# SPECIAL AIRWORTHINESS INFORMATION BULLETIN

CE-05-12  
November 4, 2004

This Special Airworthiness Information Bulletin alerts you, owners and operators of **EVEKTOR AEROTECHNIK L-13SW and L-13SE motor gliders**, that the Czech Republic Civil Aviation Authority (CAA) has issued Airworthiness Directive (AD) CAA-AD-026/2002, dated March 29, 2002. This AD calls for the installation of a metal strainer to cover the engine inlet and protect the carburetor from ingesting impurities. The following serial numbers are affected:

*issues***MANDATORY BULLETIN No. SW13-053a**  
**with effect upon airworthiness****The technical aspect approved by TI-CAA of the Czech Republic**

**MANDATORY BULLETIN****No. SW 13-053a**

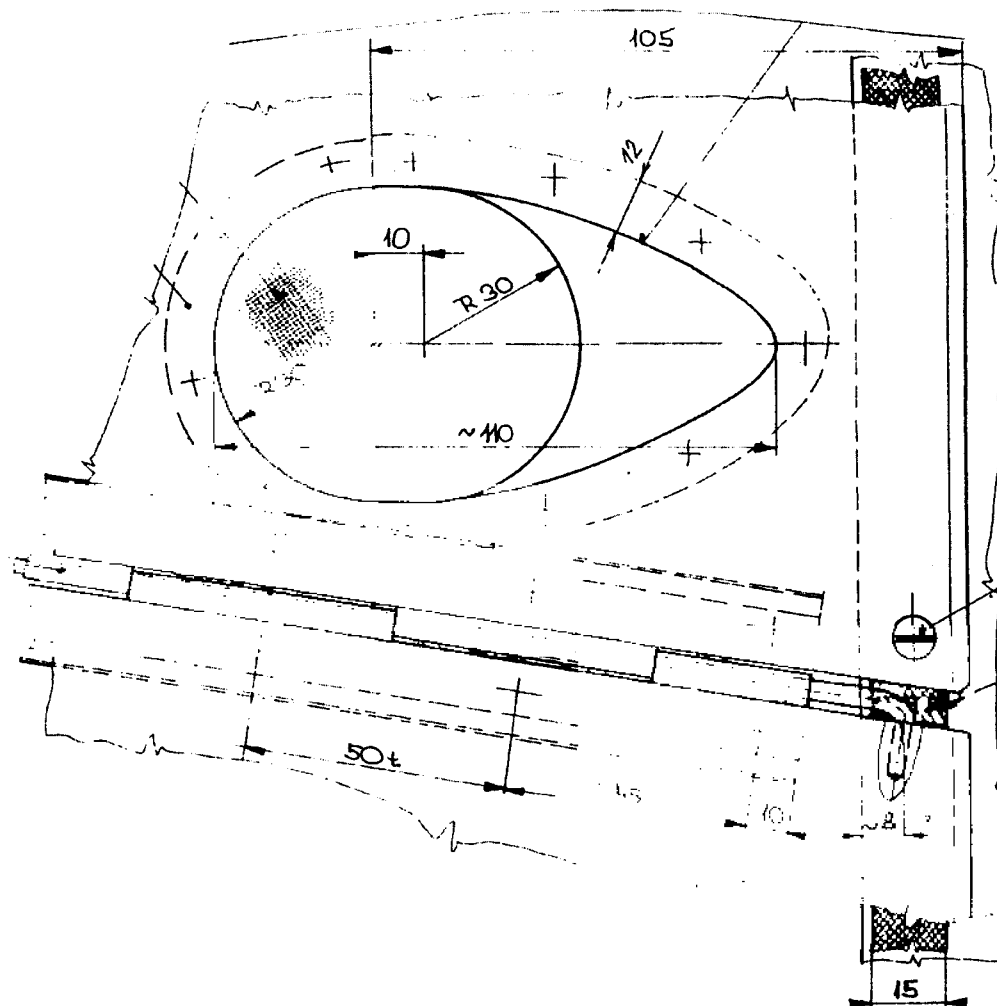
| <b>3. REQUIRED ACTION:</b>           | Protect the engine inlet hole by means of the metal strainer   |

1. Drill out the inlet hole baffle on the upper engine cover.
2. Adjust the strainer shape according to the inlet hole with the allowance of 12 mm.
3. Set the baffle with strainer to the original position.
4. Drill and joggle holes for rivets.
5. Rivet. Pack out snap heads of rivets with packing.
6. Write down the bulletin accomplishment into the operation documentation.

1. Brass strainer, max. mesh size 1x1mm, dimension 140x90..... order No. 089200.... 1 pc
2. Packing.....order No. 736224.... 1 pc
3. Rivet 2.6 x 8 ČSN 02 2311.5..... order No. 045350....10 pc
